GEORGIA POWER COMPANY
OGLETHORPE POWER CORPORATION
MUNICIPAL ELECTRIC AUTHORITY OF GEORGIA
CITY OF DALTON, GEORGIA
DOCKET NO. 50-321
EDWIN I. HATCH NUCLEAR PLANT, UNIT NO. 1
AMENDMENT TO FACILITY OPERATING LICENSE

Amendment No. 96
License No. DPR-57

SAFETY EVALUATION BY THE OFFICE OF NUCLEAR REACTOR REGULATION
SUPPORTING AMENDMENT NO. 96 TO FACILITY OPERATING LICENSE NO. DPR-57

EDWIN I. HATCH NUCLEAR PLANT, UNIT NO. 1

FIGURE 3.11-1 (SHEET 1)

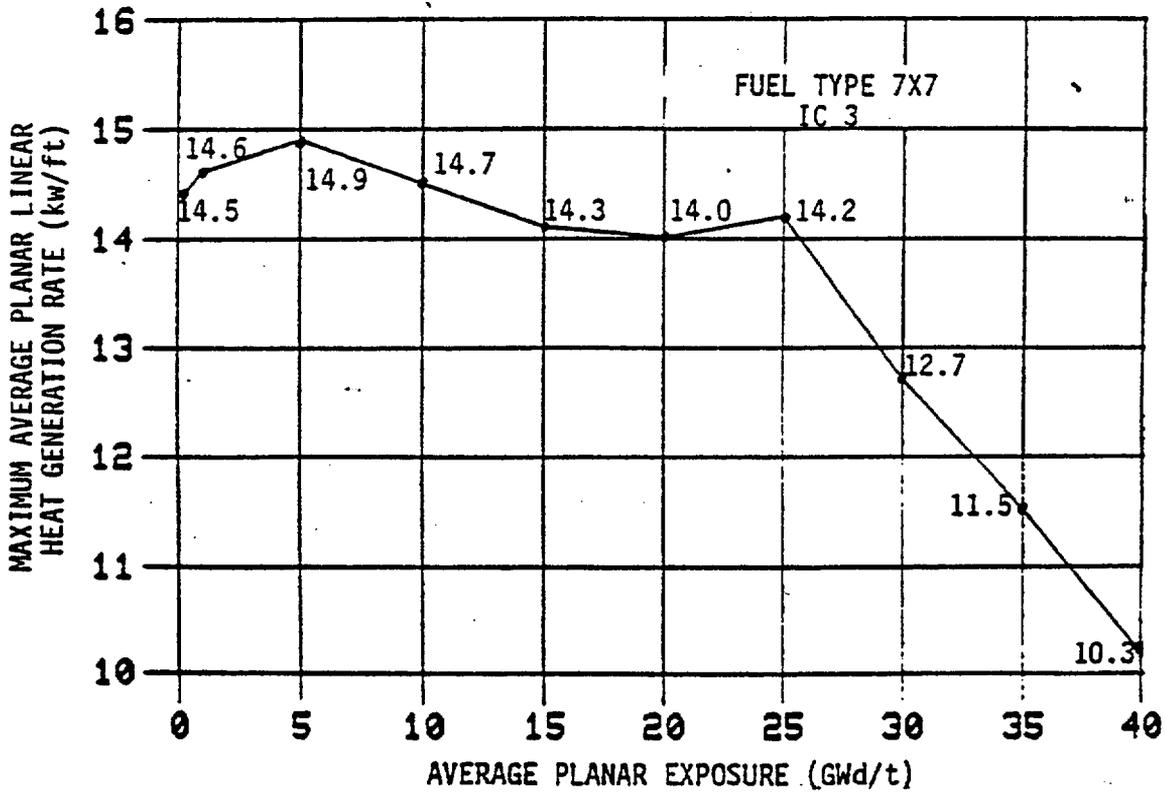
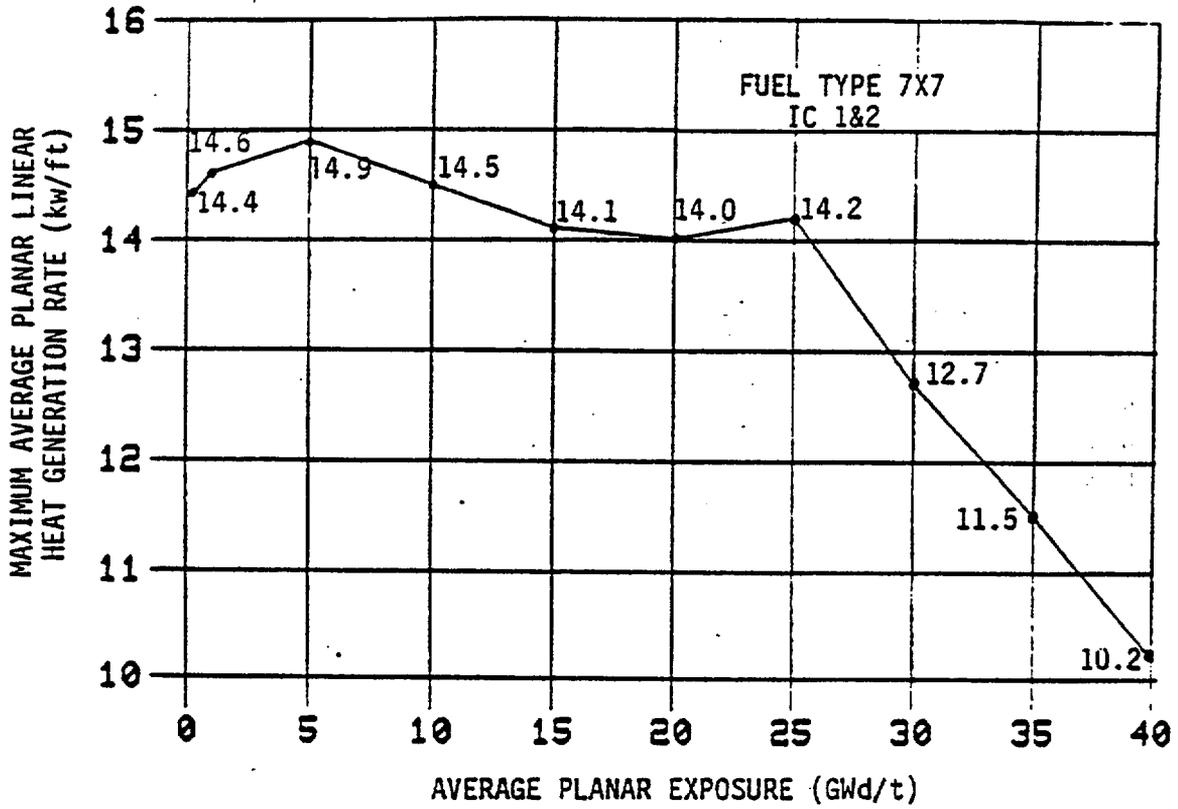
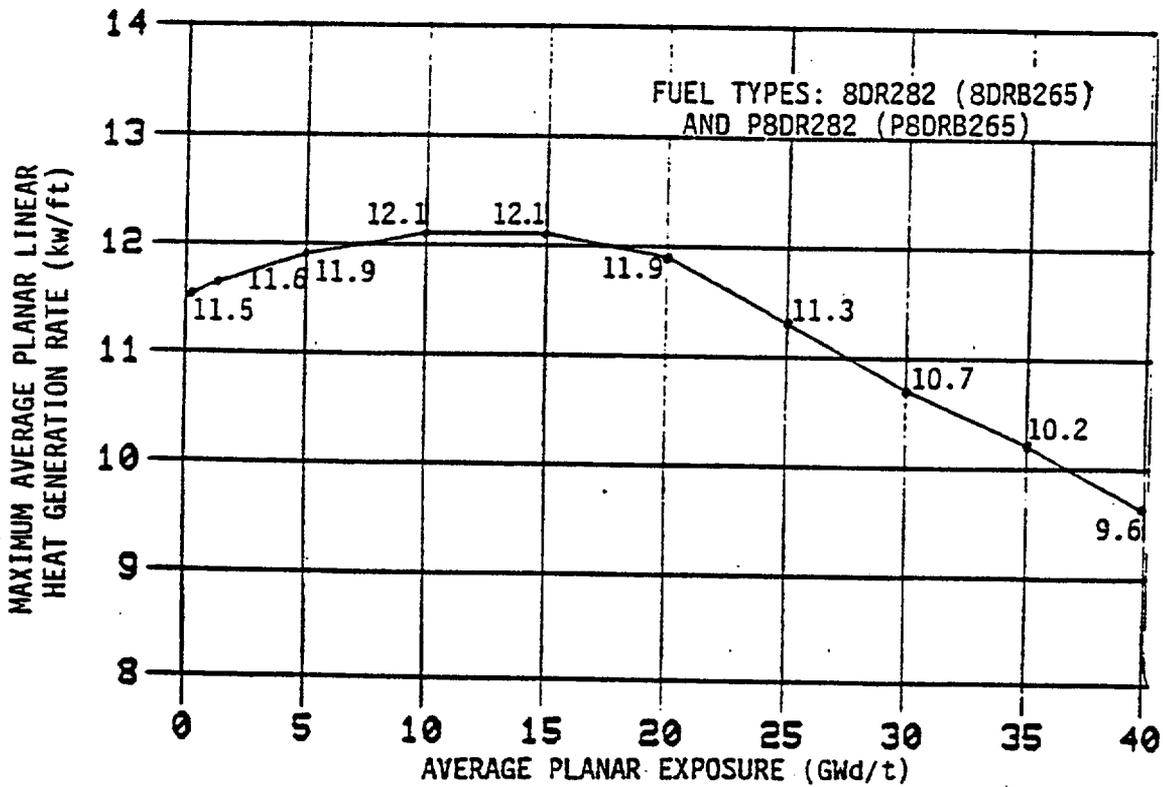
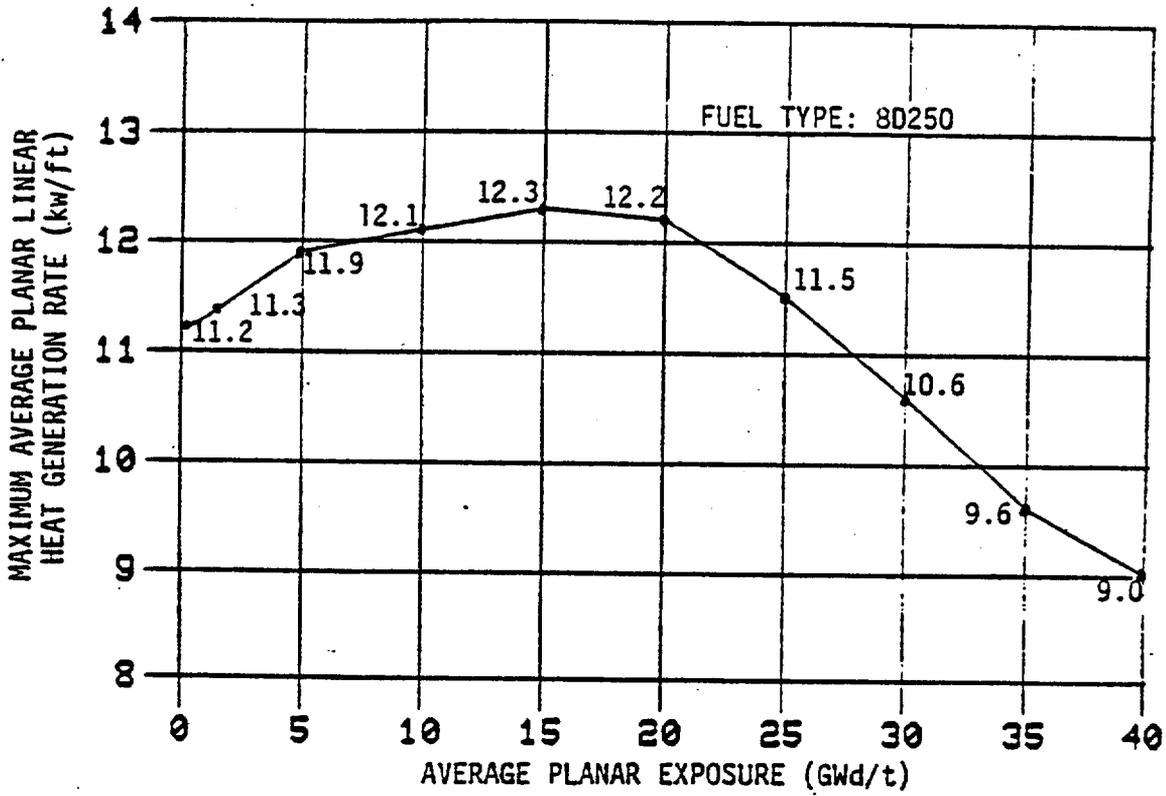
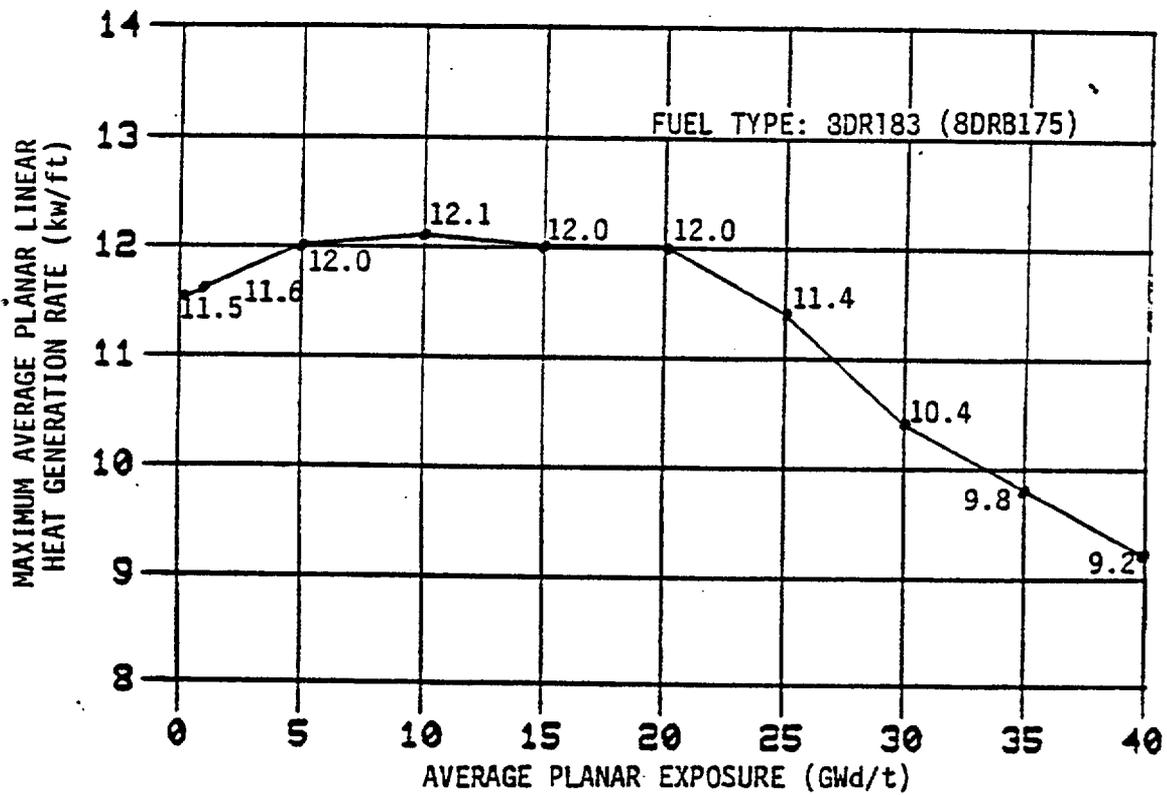
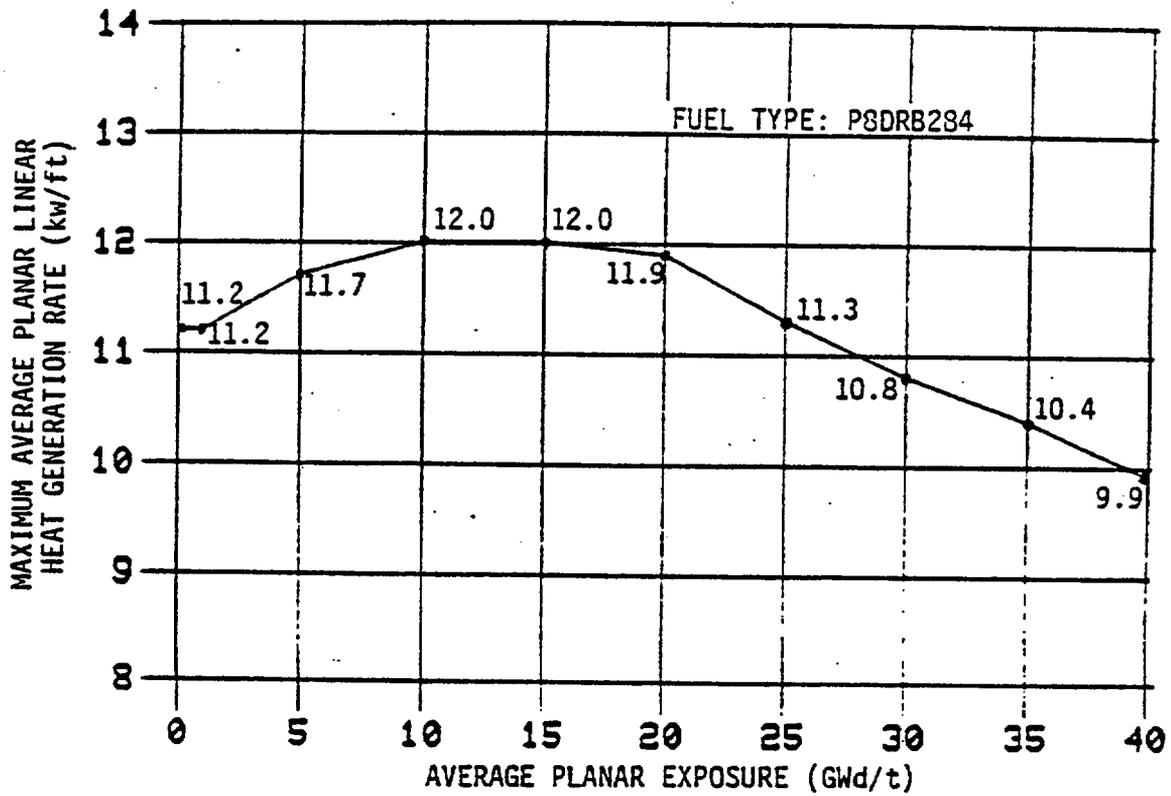
The third extends the MAPLHGR limits of Figures 3.11-1, Sheets 1, 2 and 3, beyond 30 Gwd/t based upon analyses performed by GE following approved methodology and also previously approved by the NRC staff (Ref. 2). This change is therefore acceptable.

FIGURE 3.11-1 (SHEET 5)

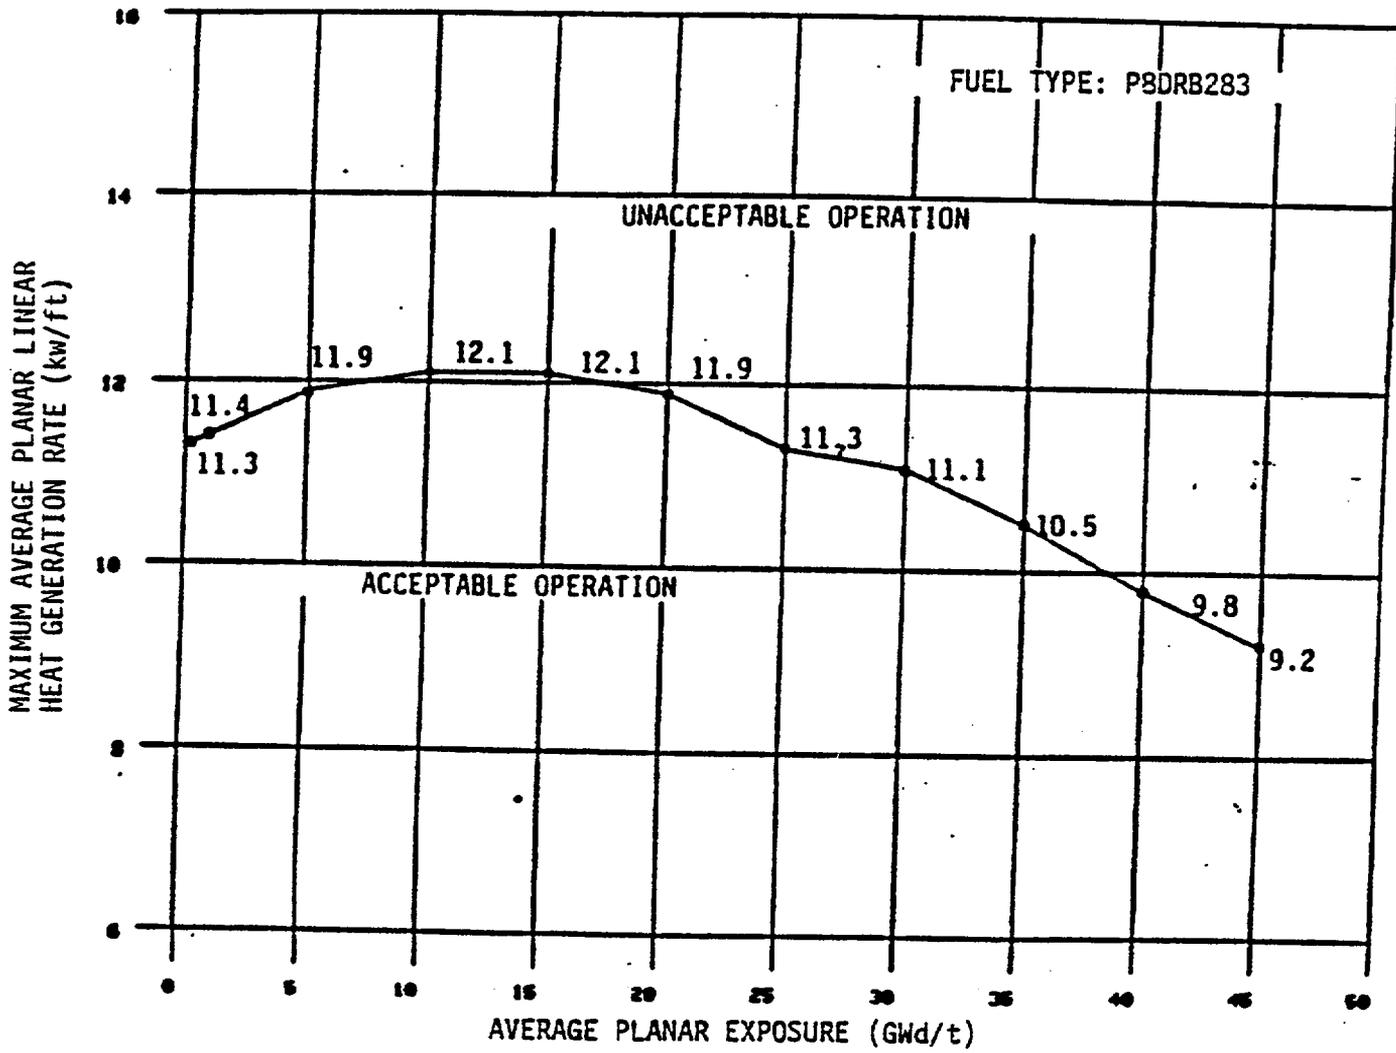
The first adds new MAPLHGR curves (Figures 3.11-1, Sheets 4 and 5) for fuel assemblies previously used in Hatch Unit 2. Their use in Unit 1 was evaluated by the General Electric Company (GE) using standard approved analysis methods and found to be bounding. This change is therefore acceptable.

MCPR LIMIT FOR 8X8R FUEL
 FIGURE 3.11.4

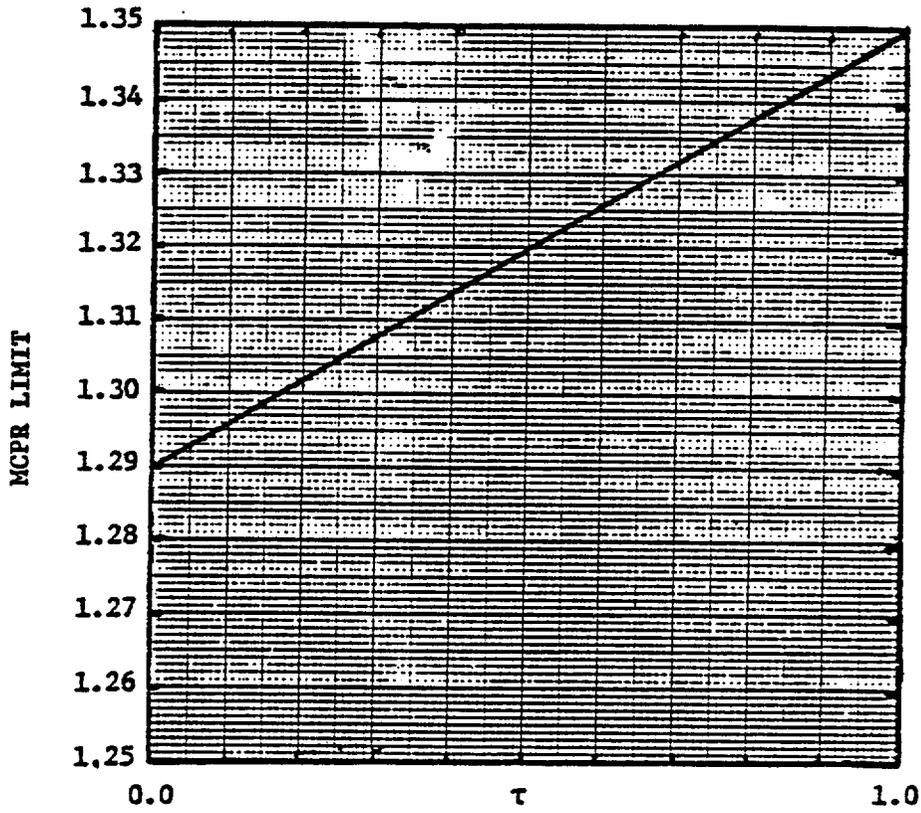
The current Hatch Unit 1 Technical Specifications require the operating limit MCPR of 1.29 for the 8X8R and P8X8R fuel as specified in Figures 3.11.4 and 3.11.5. The licensee proposes to raise the operating limit minimum critical power ratio (OLMCPR) for the 8X8R and P8X8R fuel such that the OLMCPR increases linearly from 1.29 to 1.35 with the increase of the normalized rod scram time, τ , from 0 to 1.0. This proposed increase in OLMCPR is in the conservative direction, and the new MCPR limits are chosen to provide conservative values for general core design. Even though no analysis has been provided to support the new OLMCPR values, a comparison with the Hatch Unit 2 Technical Specifications has shown that the proposed OLMCPR values for Hatch Unit 1 are higher than those for the Hatch Unit 2 8X8R and P8X8R fuel. In addition, the licensee has indicated that it will verify that these MCPR limits bound the results of all transient analyses during the licensing review of each new core design, and that it will submit a Technical Specification change if the results require it. Therefore, we have concluded that the proposed MCPR change is acceptable.
